Memorandum

SUBJECT: Shawville Addition

Resubdivision of Lots 1, 2, 3 & Reservoir Tract, Evergreen Park Subdivision and Lot 1, Block 8, Evergreen Park No. 2, and a portion of South Fifth Avenue adjacent to Lot 1, Block 8, Evergreen Park No. 2

Case Number: 23.03 FSP

PLAT OF
"SHAWVILLE ADDITION"

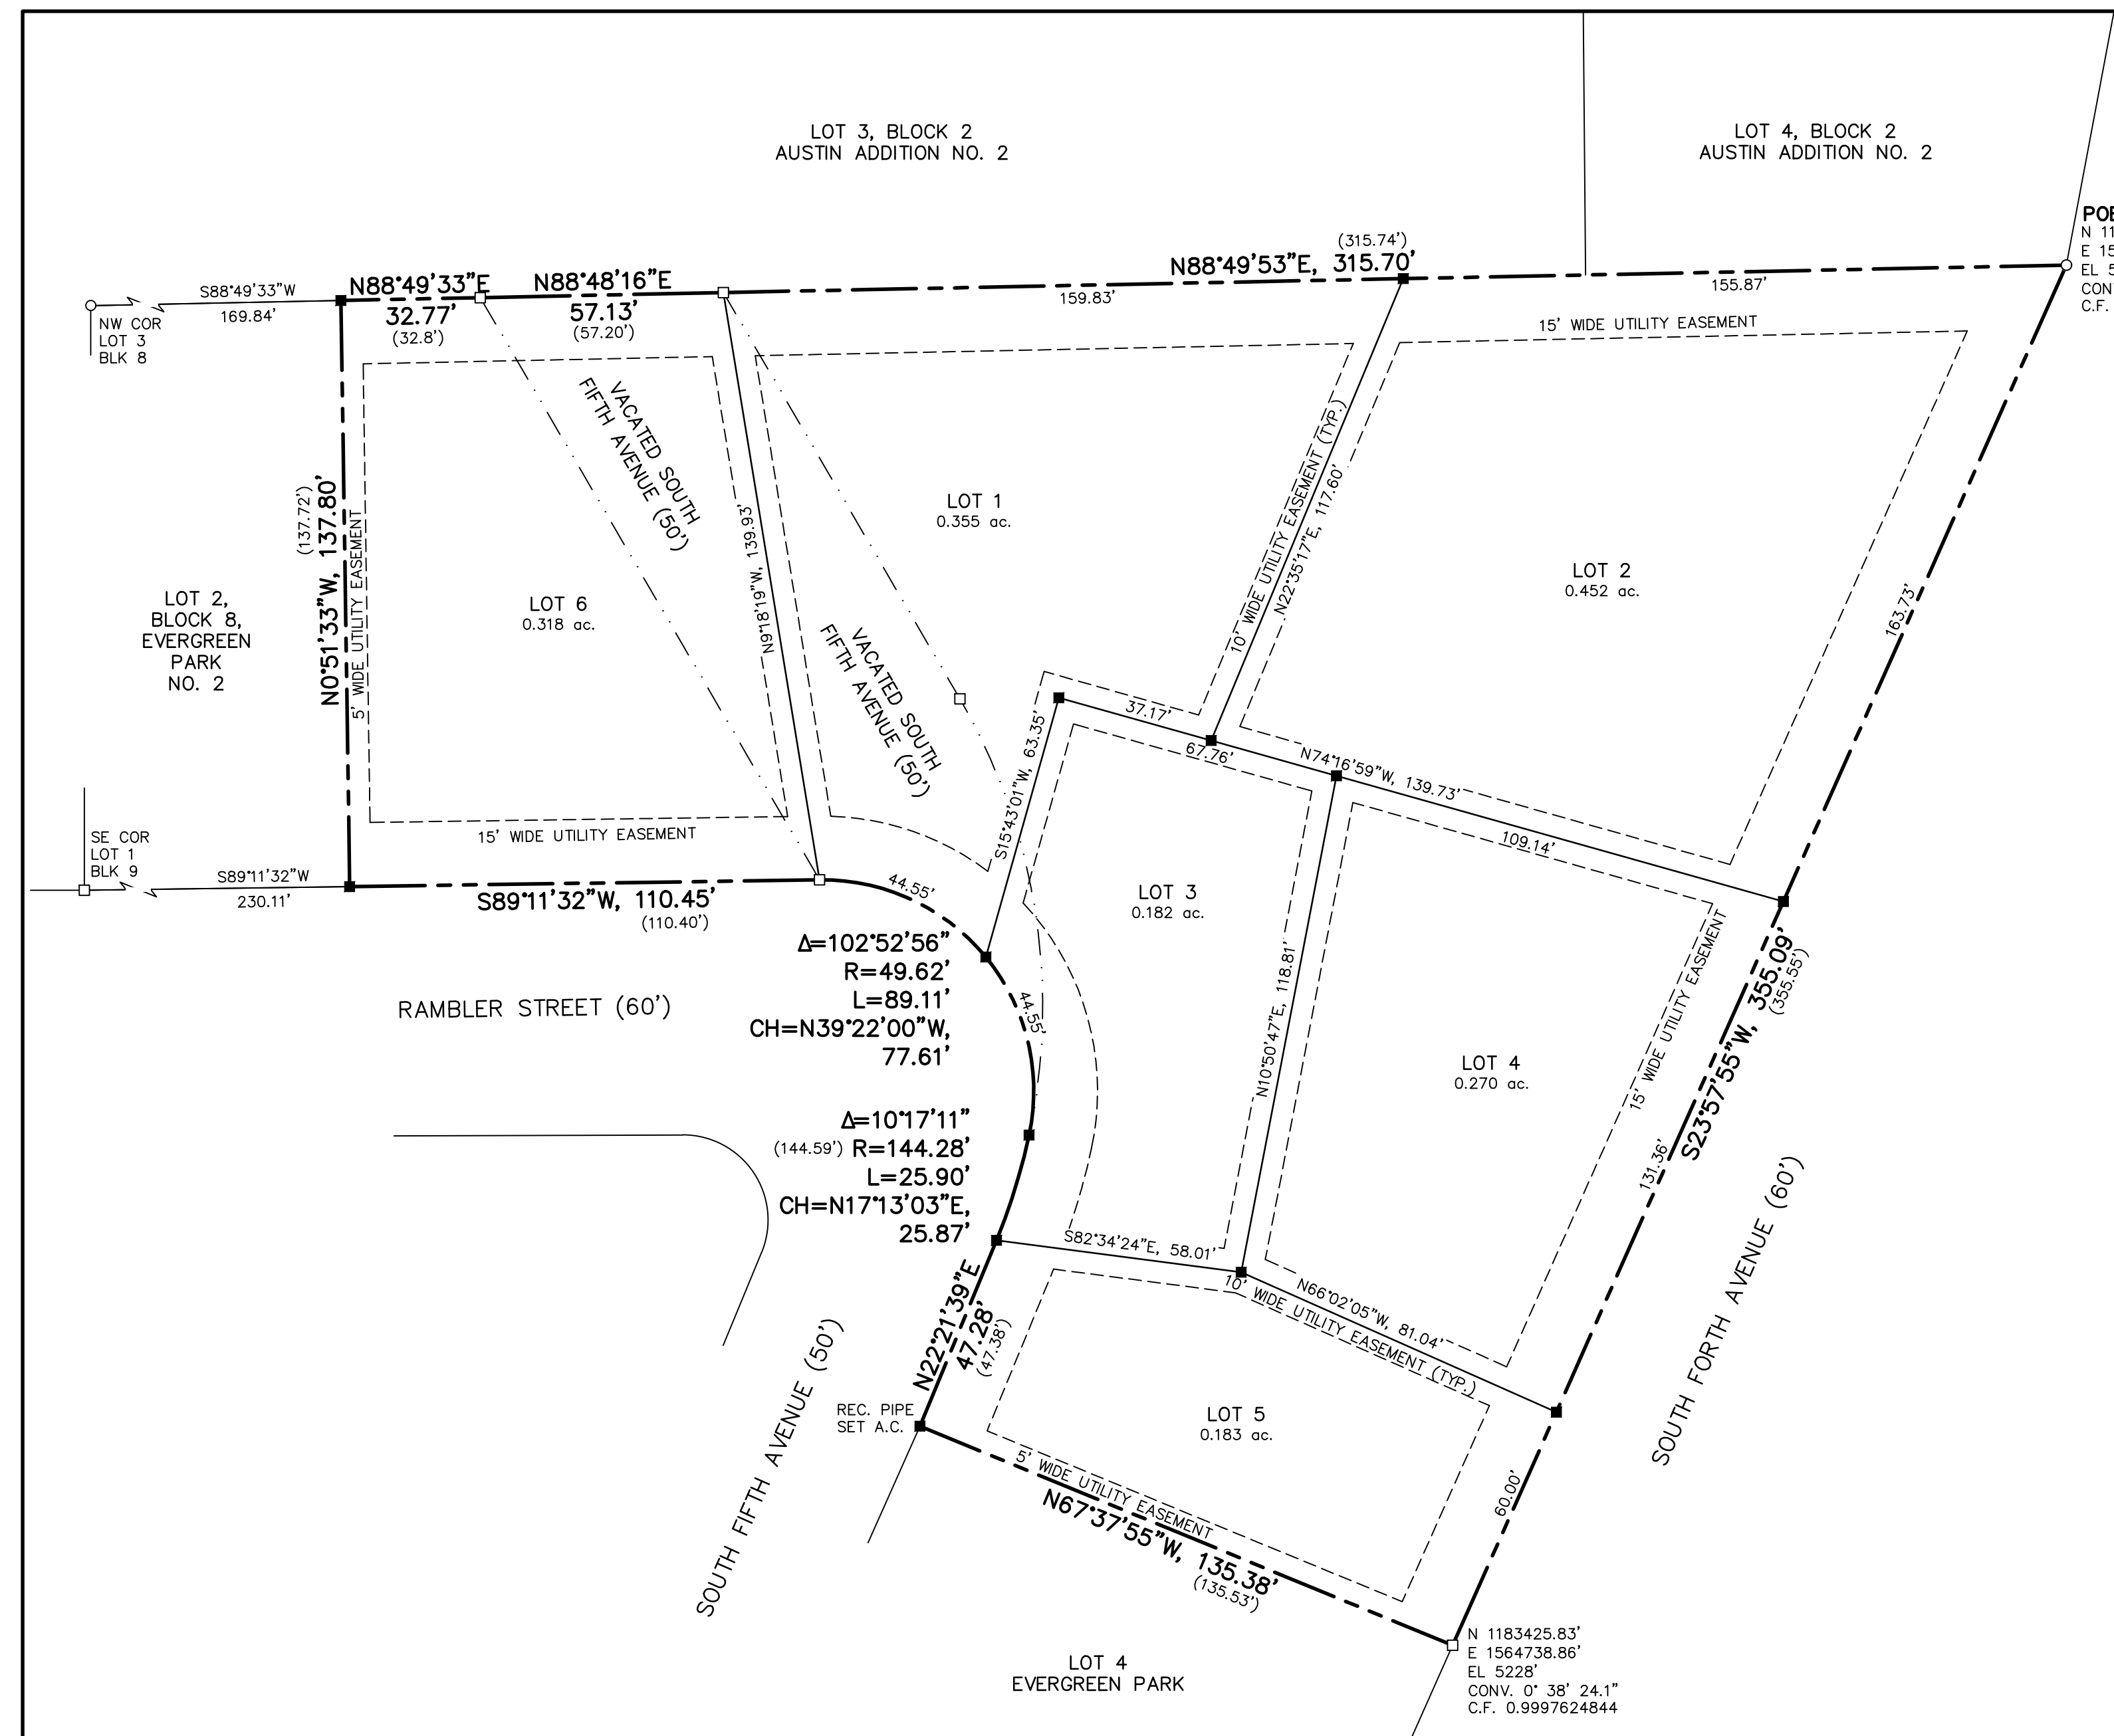
1. Verify the record owner name for the neighboring property included in the resubdivision (Lot 1, Block 8, Evergreen Park II)
2. Cosmetic Changes to the Plat
 - a. Remove the word "Attest" the City Engineer's signature
 - b. Add a legend to the plat face
3. Submit organizational documents for Shaw Investments, LLC showing who is authorized to sign on behalf of the organization.

4. Add a legend for the lines – easements property boundaries, etc.
-

1. Modify the plat to include the vacation of that portion of S. 5th Avenue and
 - a. Revise the plat title & description to include the vacation of that portion of S. 5th Avenue and Lot 1, Blk 8, Evergreen Park No. 2

- b. Modify Lot 1 and Lot 2, Blk 8 to include that vacated portion of S. 5th Avenue
 - c. Ensure all standards are met including:
 - i. Minimum lot width of 40’

- ii. All lots have access to publicly dedicated right of way
 - d. Submit a revised plat for review
2. Verify the location of all utilities and the need for any applicable utility easements

- a. Verify the needed 15’ utility easements
 - b. Ensure only needed easements are provided for the vacated portion of right of way
3. Cosmetic Changes to the Plat

- a. The owner name across the plat needs to be “Shaw Investments, LLC” per the warranty deed.
 - b. Change the name of the neighboring landowner joining the subdivision to Kimberly Perez not Sylvester Graham

- c. In the notary block, add “Managing Member” after Albon Shaw’s name
 - d. Remove the word “Attest” from the Mayor & Engineer’s signatures
4. Submit organizational documents for Shaw Investments, LLC showing who is

5. Add a legend for the lines – easements property boundaries, etc.

Megan stated that the applicants had turned in a revised plat the day before, showing the unbuilt portion of S. 5th Avenue being vacated. They also added the neighboring property owner so that the vacated portion of right of way is equally distributed between the lots and have reconfigured the lots so all have the required amount of street frontage. The City will also now sign the plat as owner since they represent the public in the vacation of the right of way.
